# HGTC BUILDING 1400 SITE IMPROVEMENTS HGTC PROJECT #: IFB0132-18 CONTRACT DOCUMENTS, TECHNICAL SPECIFICATIONS AND DRAWINGS

ADDENDUM NO. 1 06-15-2018

#### **CONSTRUCTION PLAN CLARIFICATIONS & REVISIONS**

#### STANDARD DUTY PAVEMENT SECTION

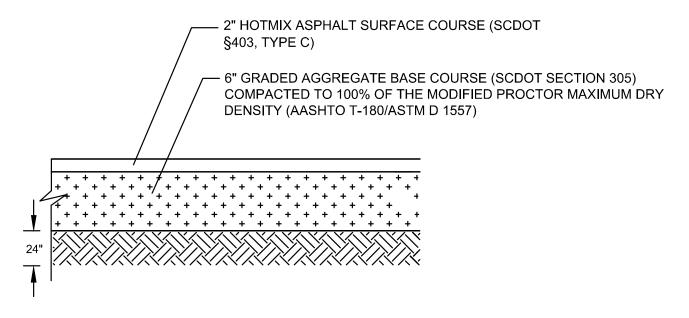
- A revised Standard Duty Pavement Section detail is attached (ADD. 1-1) The section shall consist of 2" Hotmix Asphalt <u>Surface</u> Course (SCDOT Section 403, Type C), and 6" Graded Aggregate Base Course (SCDOT Section 305).
- 2. A revised Edge Underdrain Detail and Pavement Underdrain Detail are attached (ADD. 1-2 and ADD. 1-3). The sections shall consist of #57 or #67 stone.
